STATE OF WASHINGTON
DEPARTMENT OF ECOLOGY

Re: Washington State Department of Ecology's (Ecology) Determination that the Focused Feasibility Study for the Former GE Facility (220 South Dawson Street) is Ready for Public Comment

Re: Ecology Comments on the Draft Revised Focused Feasibility Study (FFS) Report, dated
October 17, 2008

GE - S. DAWSON STREET 02978-4-15-735		ALTERNATIVE 5
DATE: 6/9/08	DRWN: E.M./SEA	FIGURE 5-6

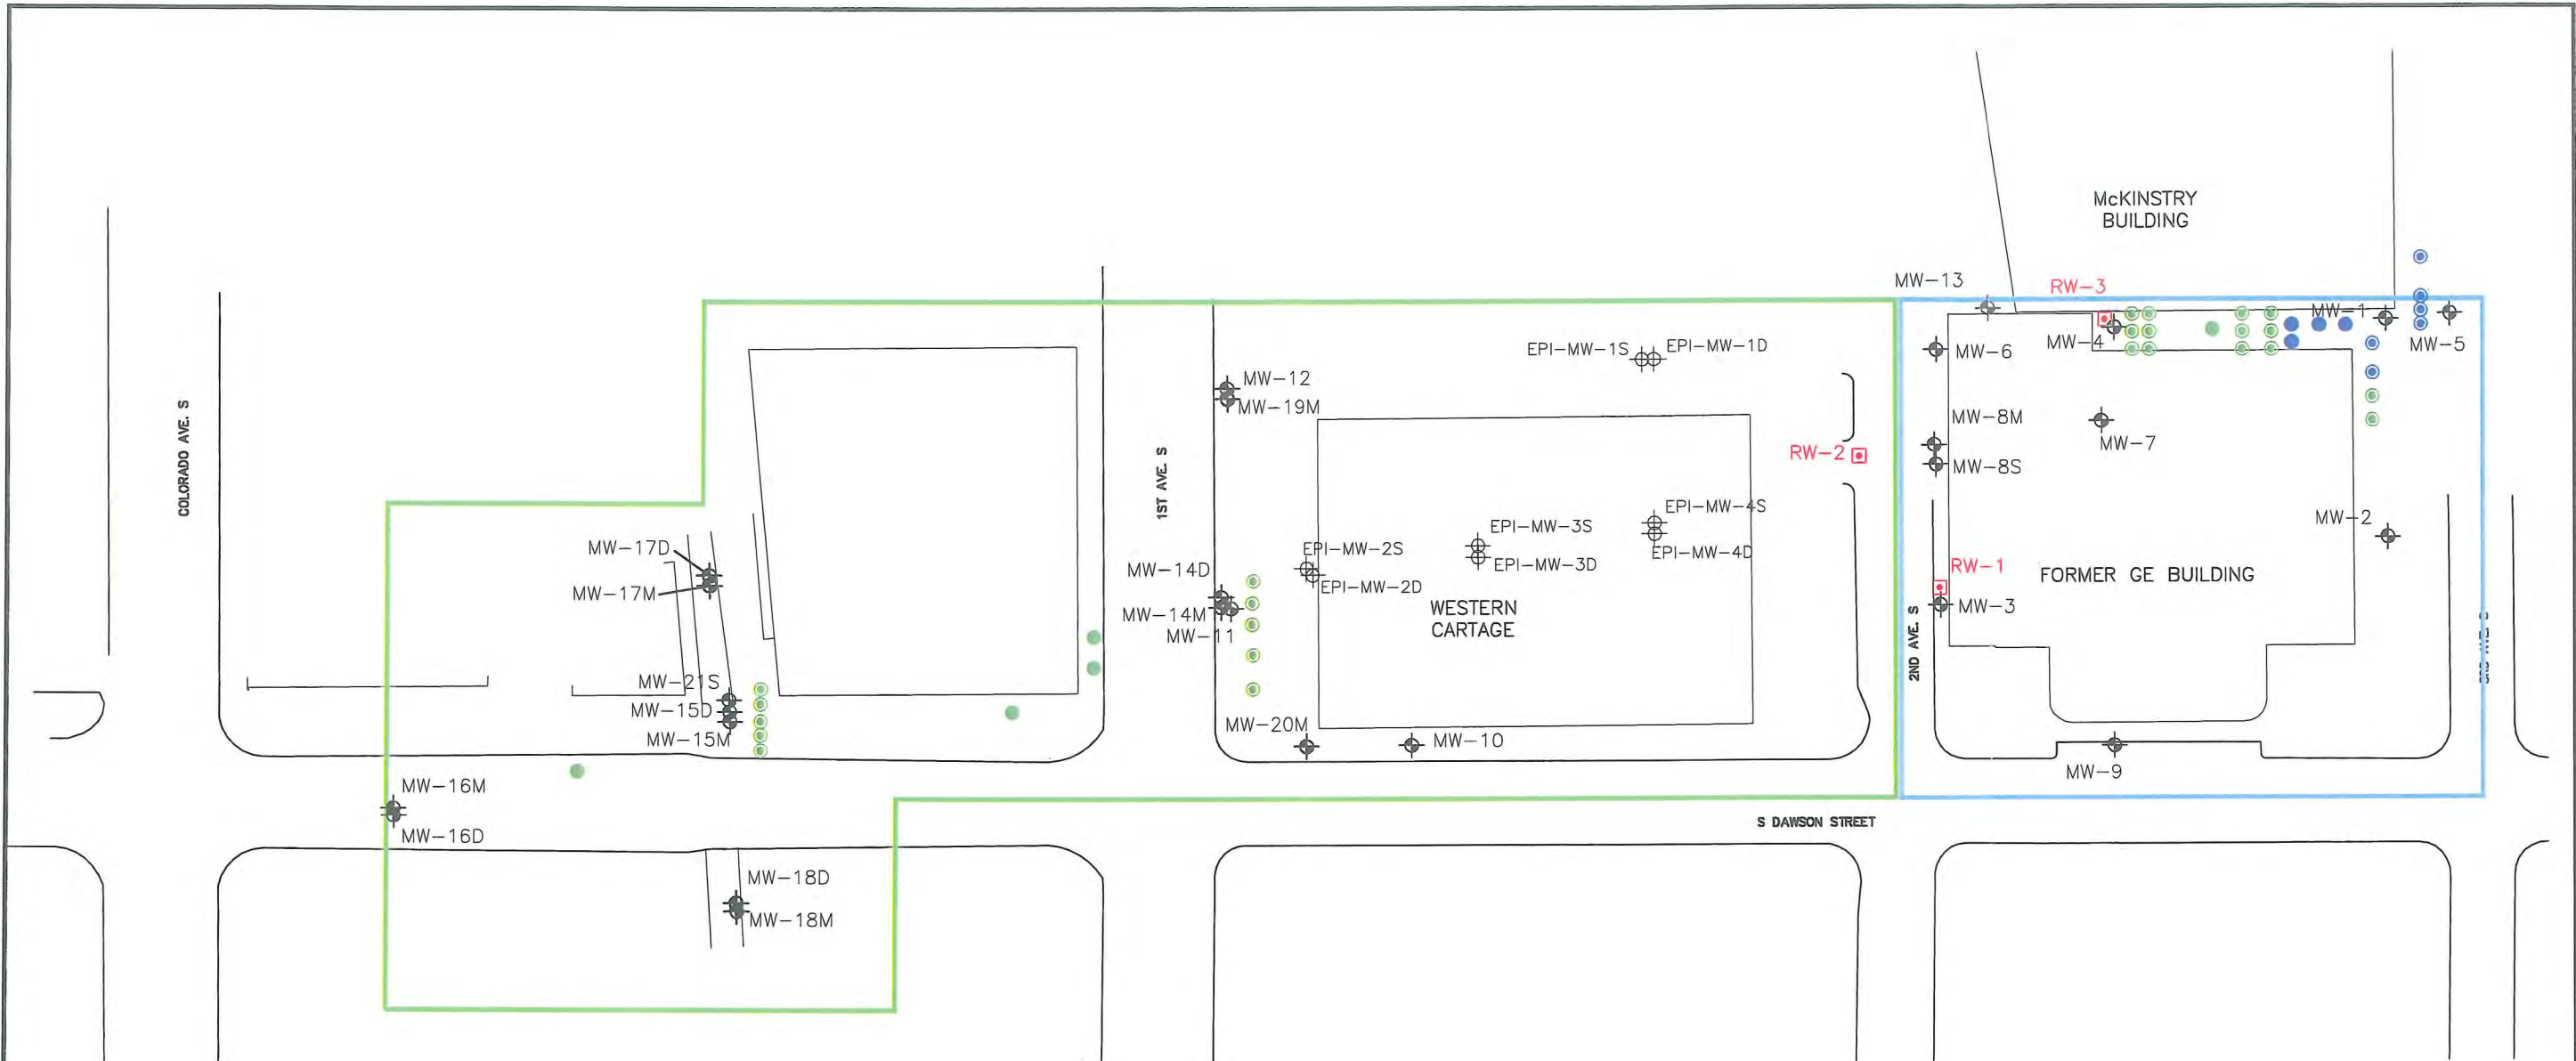
injections to the full depth of the off property plume, at 55 feet bgs. (Ecology notes that Figures 5-3 and 5-6 stated these deeper injections would occur). In addition, per Ecology's August 14, 2008 letter, GE did not, but needs to, revise these figures and the Section 5.3 text to include ISCO injections at 2nd Avenue South, upgradient of the Western Cartage building.

I.c.- Relocation of the groundwater extraction wells and pumping rates. As part of the hydraulic control optimization for alternative #7 alone, GE should analyze relocating both extraction wells, RW-2 and RW-3 to the east side of 2nd Avenue South.	Addressed	Section 5.3 updated to reflect Ecology's comments related to Alternative 2, Figure 5-3 was also updated.
I.d.- Offsite ISCO Injections. GE's proposed offsite injection points near MW-15D/M will not be deep enough to treat the CVOCs at the maximum known depth of 55' bgs. Since monitored natural attenuation is not proposed as part of the final remedy, the injection wells near MW-15D/M should therefore extend down to at least 55' bgs.	Addressed	Section 5.3 was updated to include an additional observation well set screened at the deeper portion of the aquifer is included in Alternatives 2 and 5 (under Phases 2 and 5). Figures 5-3 and 5-6 were updated.

Figure 5-9 TCE Concentrations in On-Site Area Wells (1992 -2008)

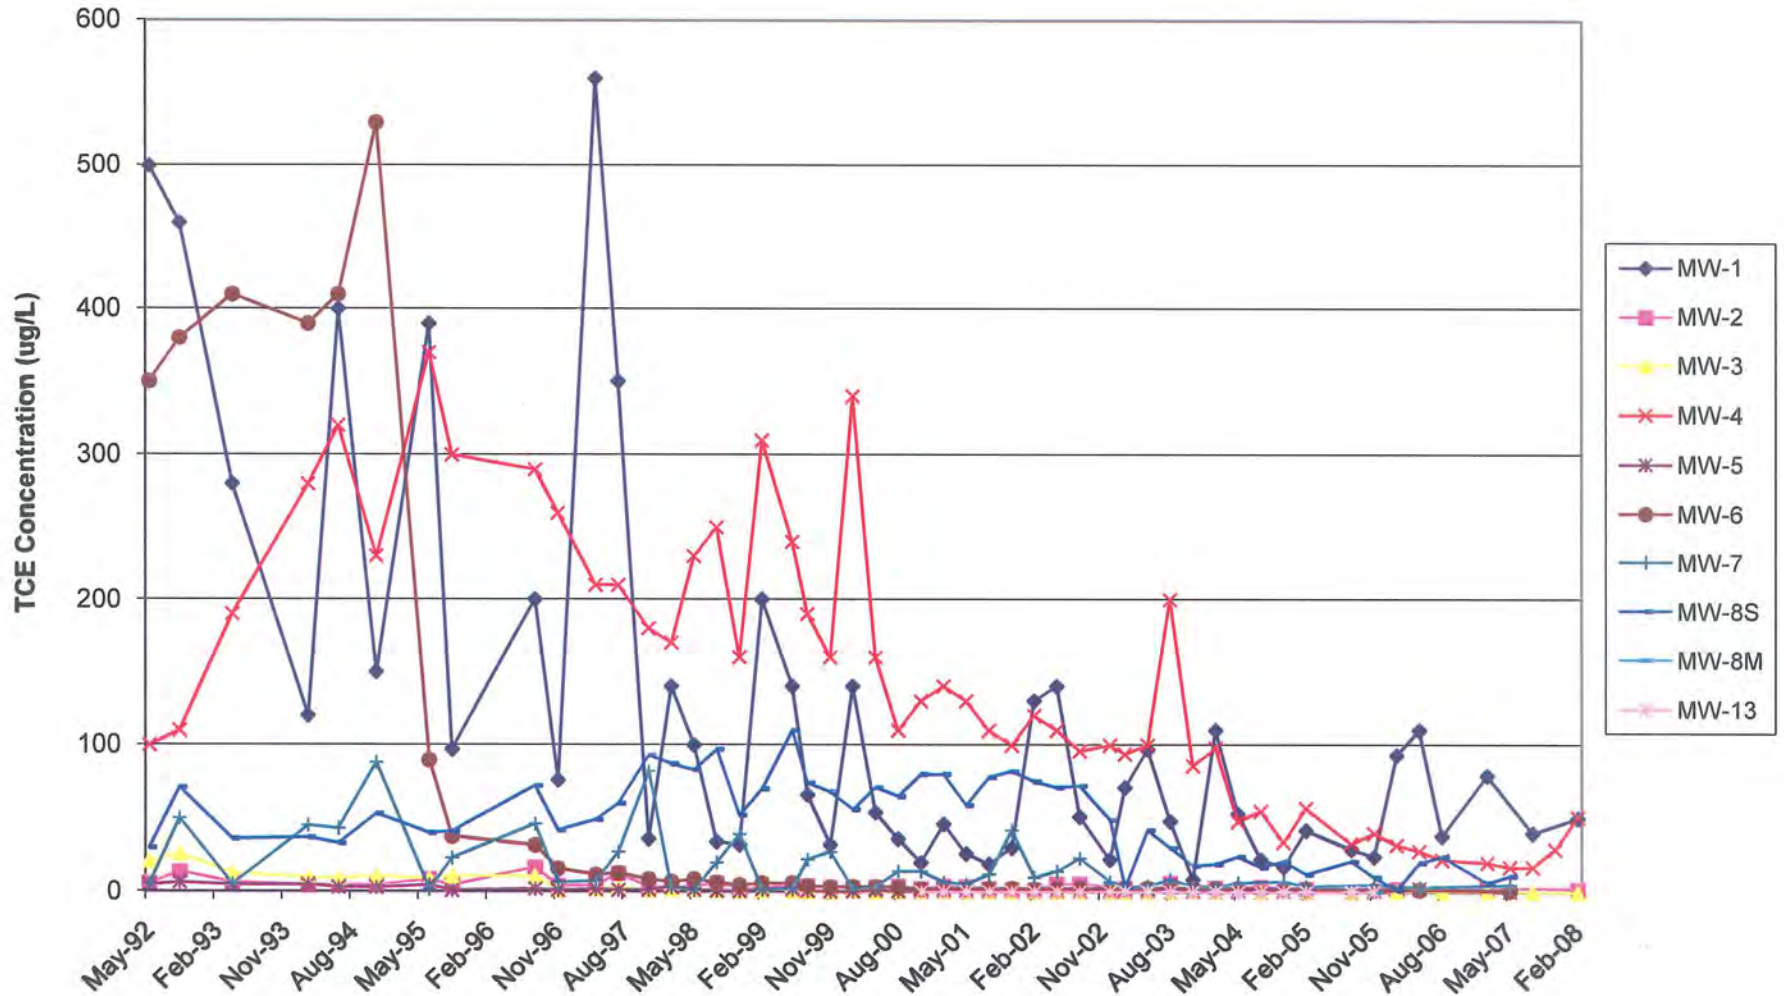
57. Page 5-25, Section 5.6.1.2, Paragraphs 2: Figures 5-9 and 5-10 are not the figures that the text referred to. The figure discrepancy needs to be corrected.
